**RFB-2023-54**  
**SCHENECTADY COUNTY RAY WEMPLE RINK ADDITIONS AND RENOVATIONS**  
**C2 DESIGN GROUP**

**ADDENDUM #6**

Issued Date: 12/28/2023

1  
 SKA-02

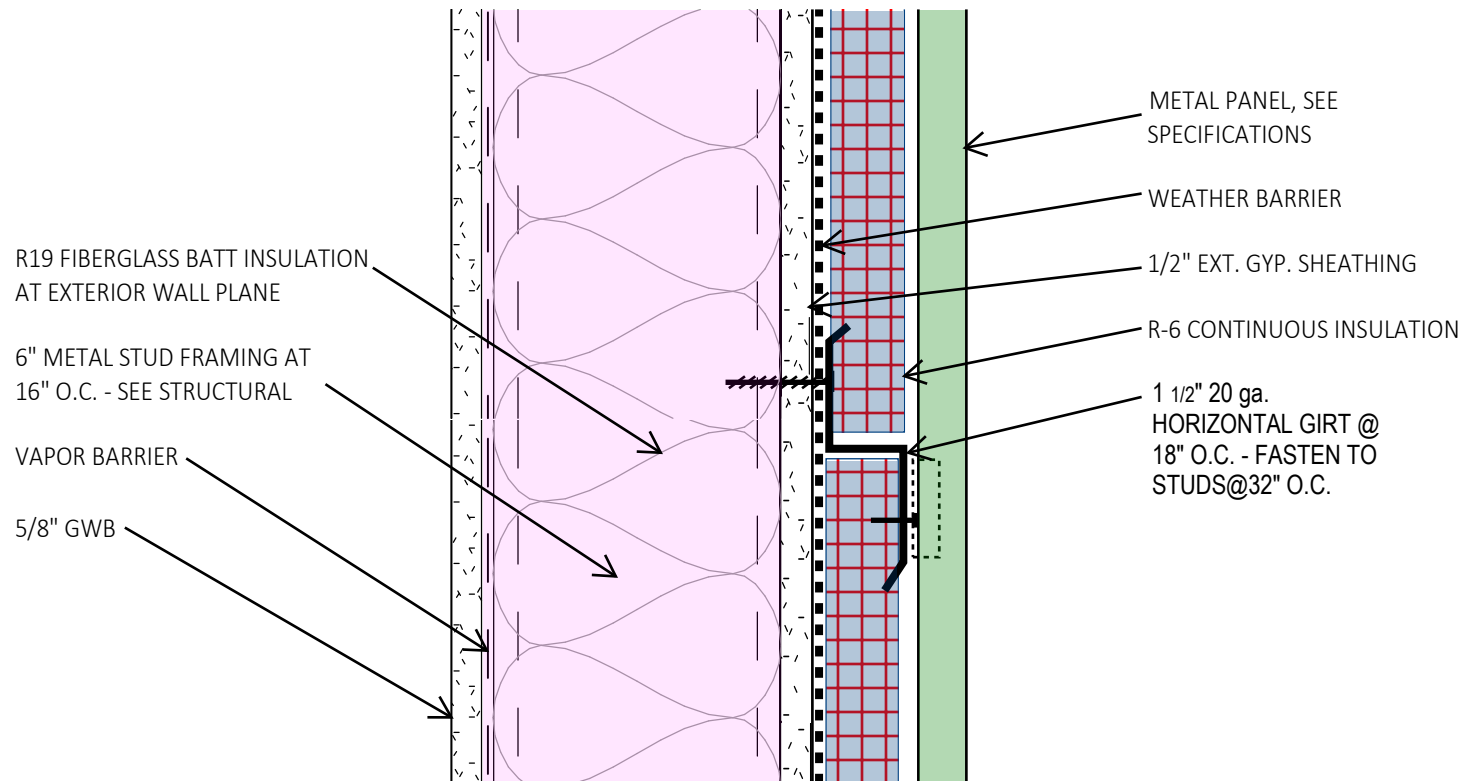
8. Confirm Metal Panels, MP-1, MP-2, MP-3 and MP-4 will require horizontal support at 24" o.c., such as 1.5" Z-girts, 20 ga, set in plane of 1.5" rigid insulation envelope.

- a. Response: Z-girts are required. See attached SKA-02.

NOTE: TYPICAL FOR METAL PANEL TYPES  
MP-1, 2, 3, & 4 (INSULATION, SHEATHING,  
AND WEATHER BARRIER LOCATION VARIES -  
SEE BUILDING SECTIONS)
